HUMAN FACTORS ENGINEERING REVIEW AND EVALUATION
WEAPON SYSTEM 107A-2 LAUNCHER, OSTF AND TF-1
FINAL REPORT

CONTRACT NUMBER AF 04(647)-138

AMERICAN MACHINE & FOUNDRY COMPANY

HUMAN FACTORS ENGINEERING
REVIEW AND EVALUATION OF TITAN WEAPON
SYSTEM 107A-2 LAUNCHER, OSTF & TF-1

FIGURE 8-1
HUMAN FACTORS INPUTS
COMMUNICATIONS SYSTEM

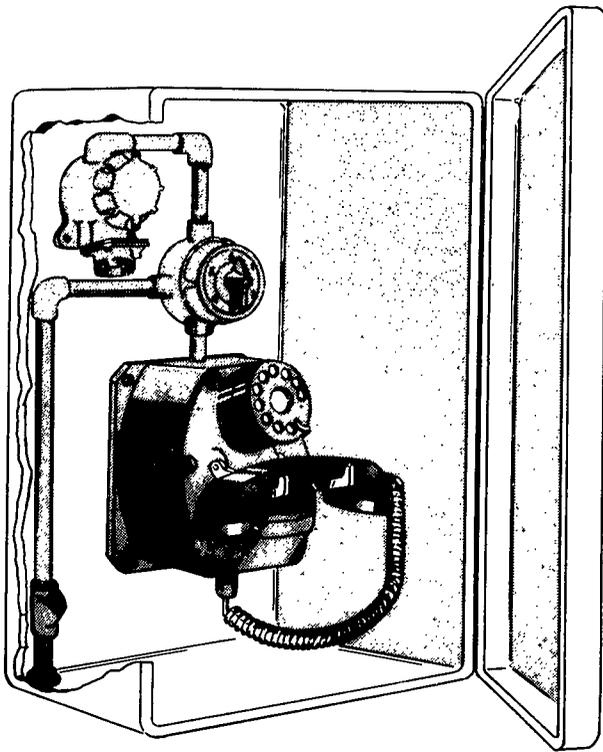
The personnel elevator telephone should be located within tolerance limits with respect to operator's hand and eye heights.

Telephone stations are mounted in accessible locations recommended in AMF drawing #150-268.

FIGURE 11-1
HUMAN FACTORS INPUTS
CRIB-TO-SILO BRIDGE

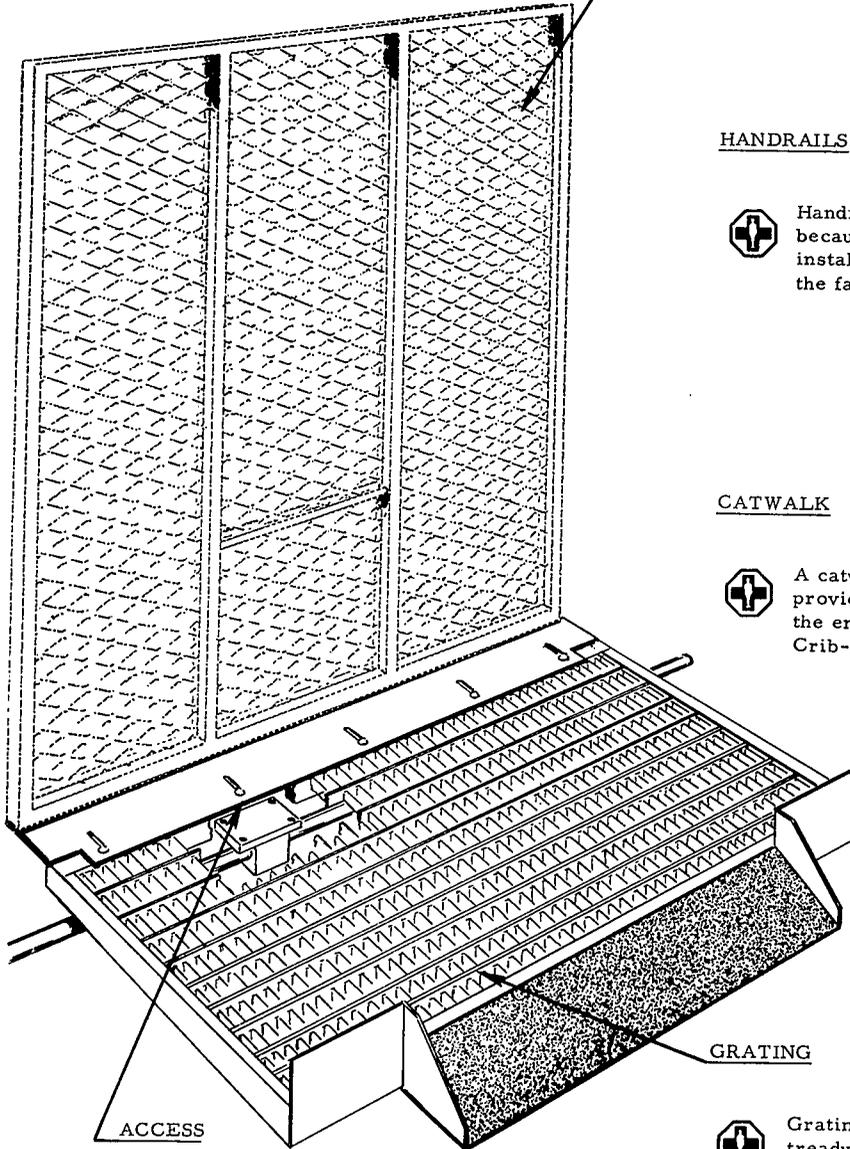
The bridge dimensions provide adequate area for the movement of the men and equipment to be transported from the Personnel Tunnel to the Personnel Elevator.

A gate has been added to protect personnel from the danger of the open elevator shaftway.

A catwalk has been added to provide safe passage between the emergency ladder and the Crib-To-Silo Bridge.

FIGURE 12-1
HUMAN FACTORS INPUTS
LIFTING AND HANDLING DEVICES

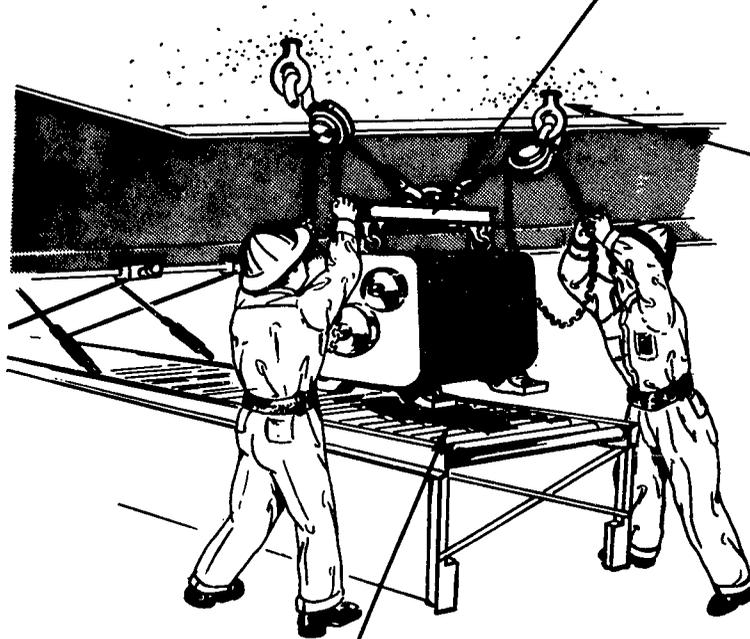
Strongbacks have been recommended to distribute heavy loads evenly.

All components which are above the safe limit for a man to lift must be provided with some special handling means.

FIGURE 13-1
HUMAN FACTORS INPUTS
TRAILER, LIFT & MAINTENANCE
DOLLY

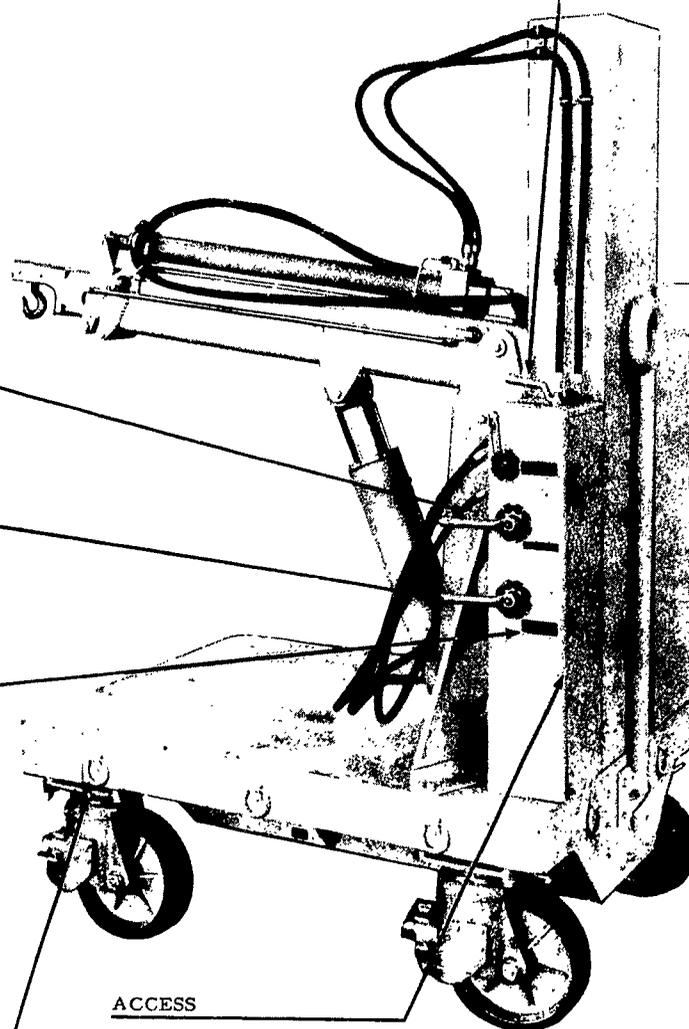
Warning signs shall indicate load capacities and proper hydraulic fluids.

FIGURE 13-1
HUMAN FACTORS INPUTS
TRAILER, LIFT & MAINTENANCE
DOLLY

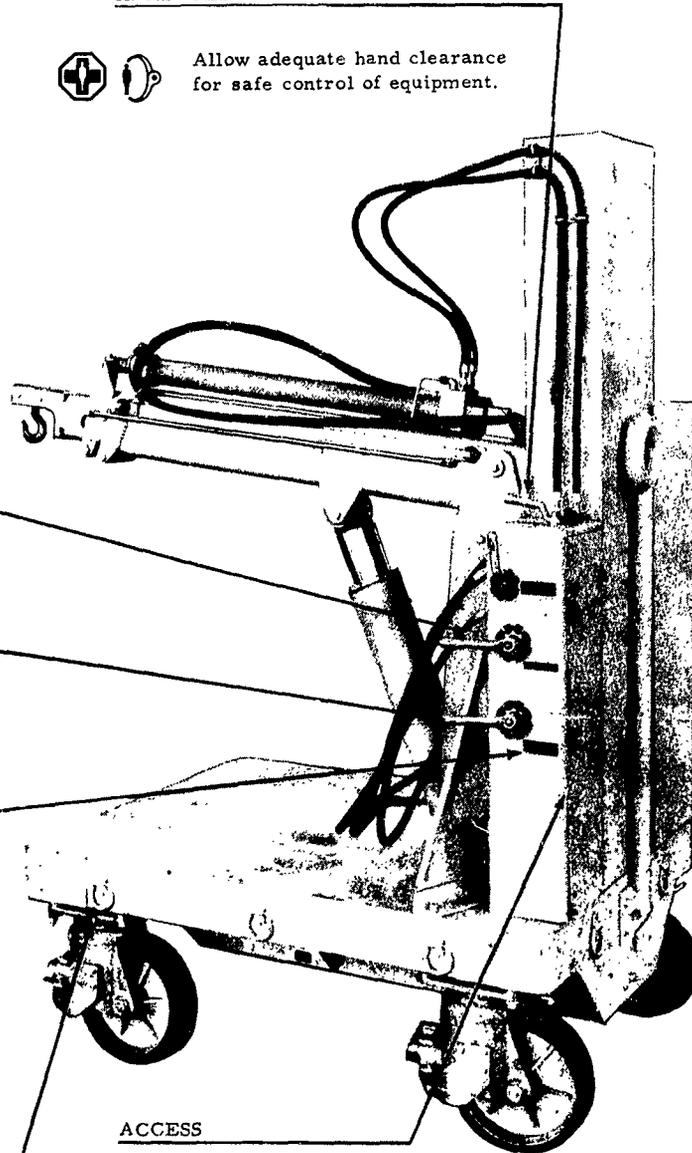
Pitch boom control lever should be at least 30 inches above standing surface.

Labels should follow controls into optimum areas of reaching and seeing.

FIGURE 14-1
HUMAN FACTORS INPUTS
MISSILE EMPLACEMENT

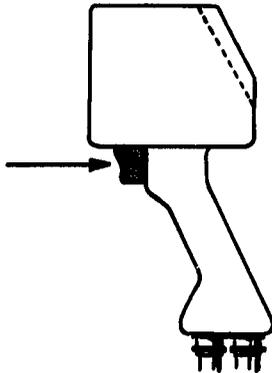
Arrangement of controls should be consistent from application to application.

A dead-man trigger switch has been provided to insure fail safe conditions.

FIGURE 11-3
HUMAN FACTORS INPUTS
SILO MOUTH PLATFORMS
AND
TAG LINE WINCHES

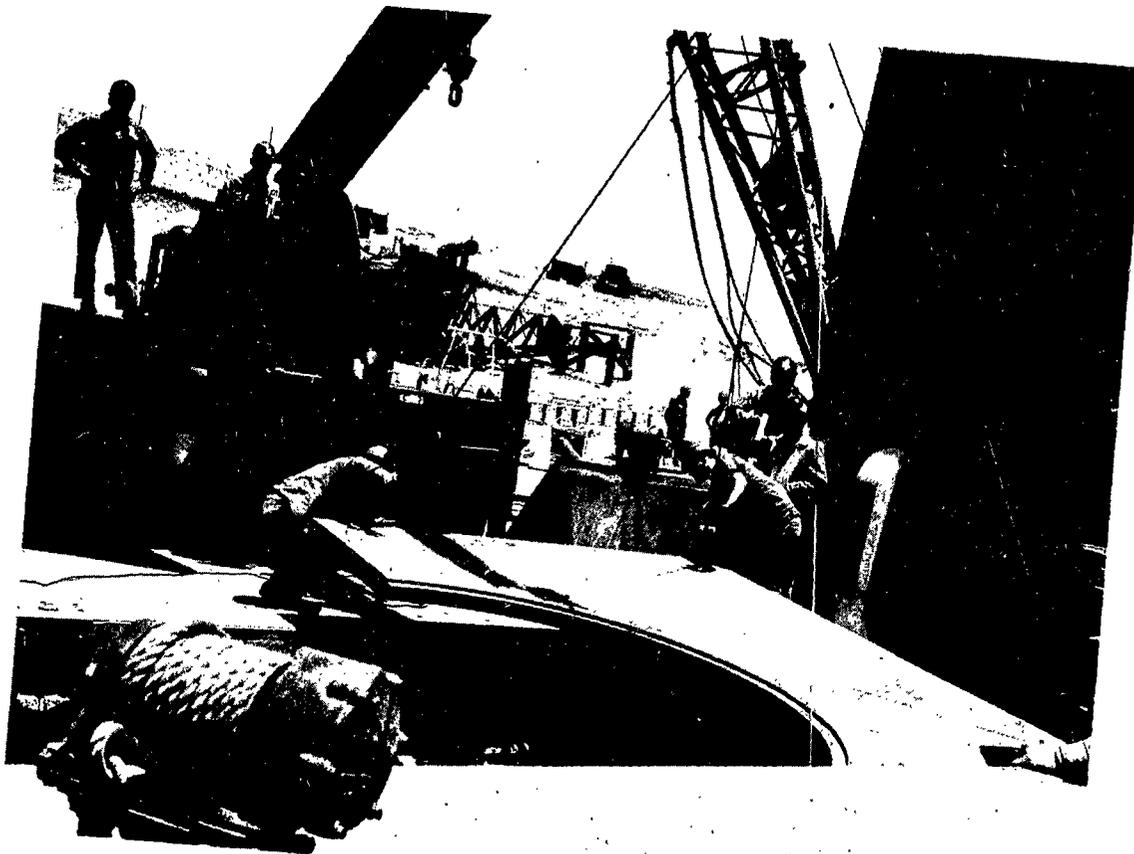
Tag line winches should be located for optimum standing operation of the crank.

FIGURE 15-1
HUMAN FACTORS INPUTS
MOBILE WORK
PLATFORM

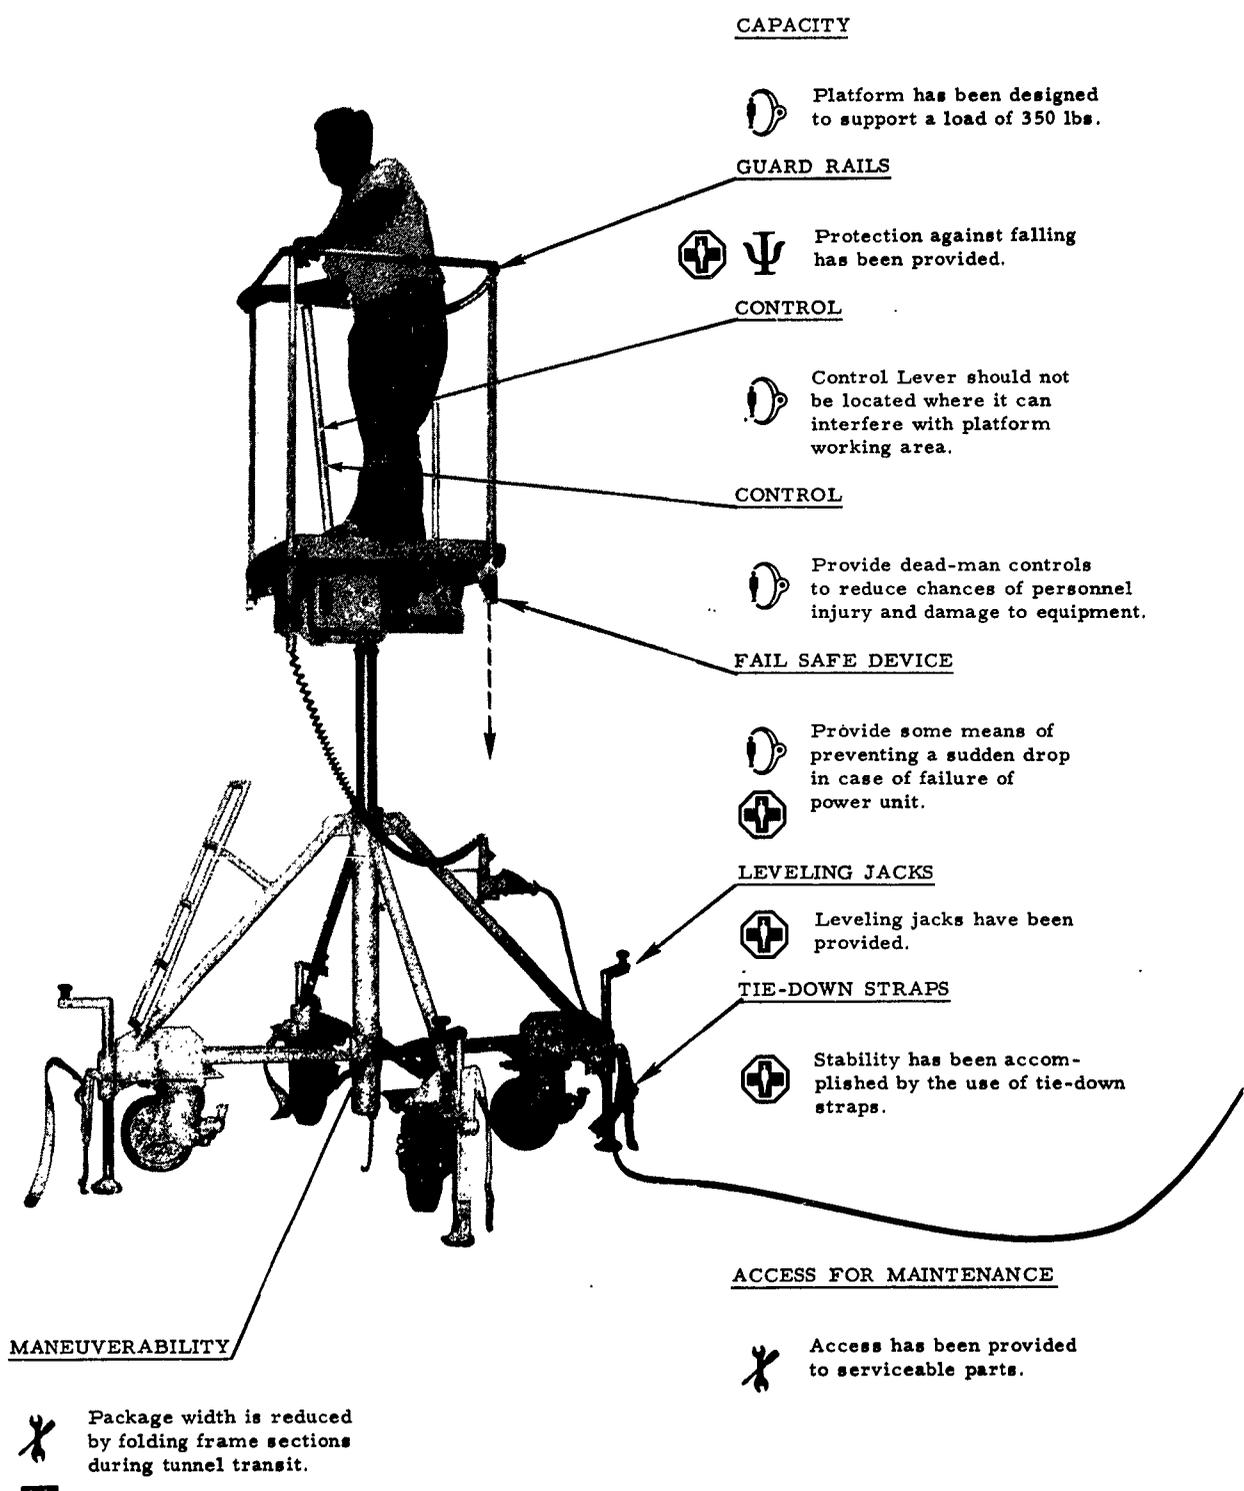
Package width is reduced by folding frame sections during tunnel transit.
